Subject: 10" and 12" Magnet Spring and Lever Arm Update

PRODUCT BULLETIN #389

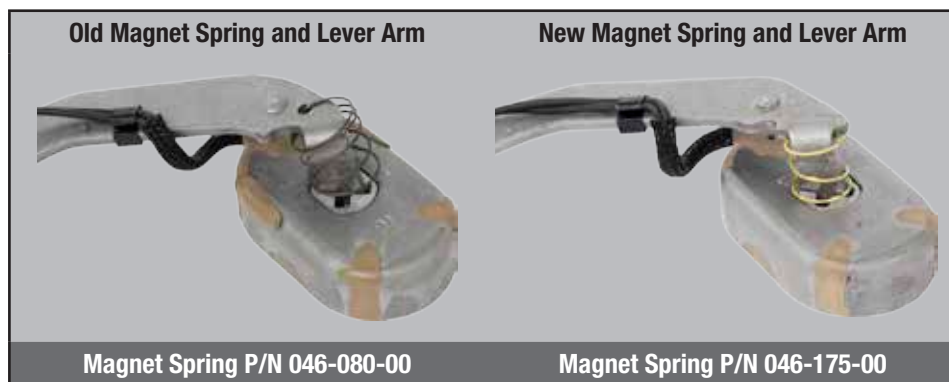
Magnet Spring – The 046-080-00 will be replaced by 046-175-00. The new magnet spring changes shape, requiring a smaller circumference as the new larger magnet lever arm provides a more consistent mounting surface. The change also removes the hassle of inserting the magnet spring into the lever arm during assembly.

Magnet Lever Arm – The lever arm part numbers do not change and will continue under the same part numbering scheme. The updated lever arm utilizes additional material at the base of the anchor post and can be identified by the lack of an indexing hole used for the previous magnet spring (see pictures below).

The new magnet spring and lever arm are compatible with all previous brake assemblies, but must be changed in conjunction with each other. Changing either component individually will create fitment issues and should be changed together. All existing magnet assemblies are compatible with the new magnet spring and lever arm. Moving forward, magnet service kits will include both the new and old magnet springs. As with all magnets, they should be replaced in pairs – both sides of the axle.
